ADDENDUM NO. 2

KEY WEST HISTORIC SEAPORT PILING REPLACEMENT& PIER REPAIR

ITB 15-019

Exhibit 1

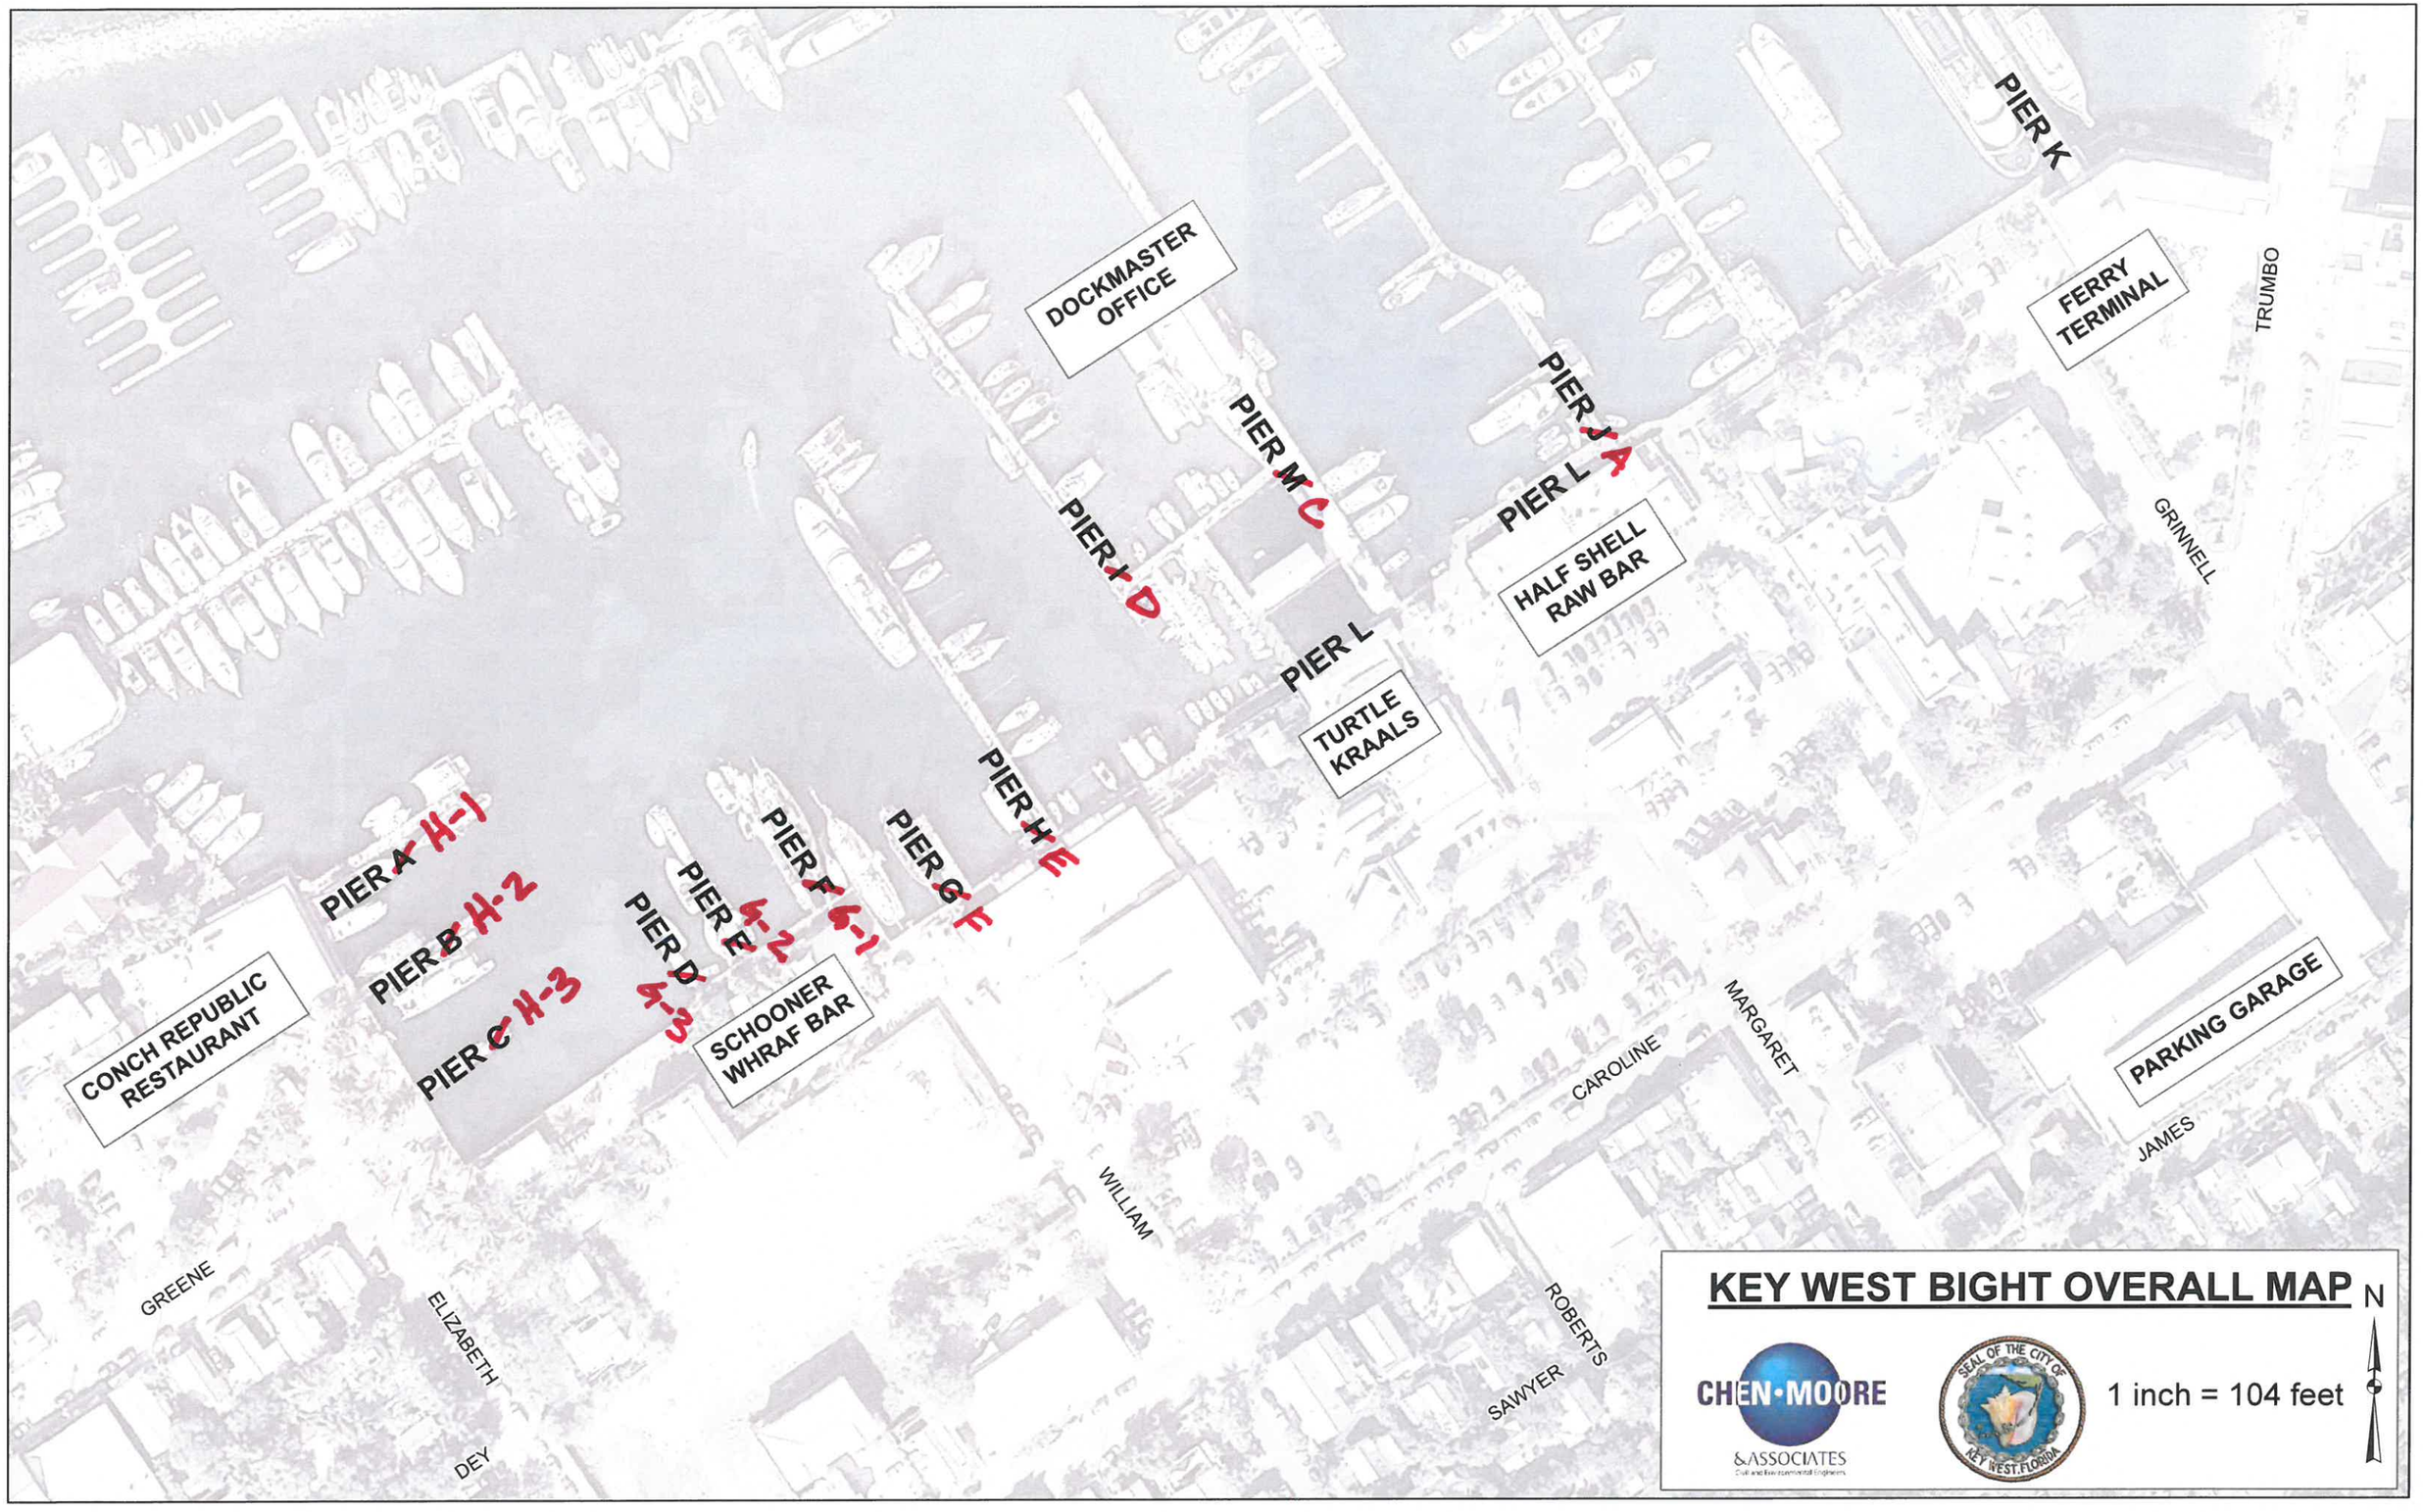
1. The Docks alphabetized names do not match what was included in the "PILING ASSESMENT REPORT".

Please see attached marked –up dock layout with the correct lettering A, C, D, E, F, H-1, H-2, & H-3. Docks G-1, G-2 & G-3 were newly labeled for this project.
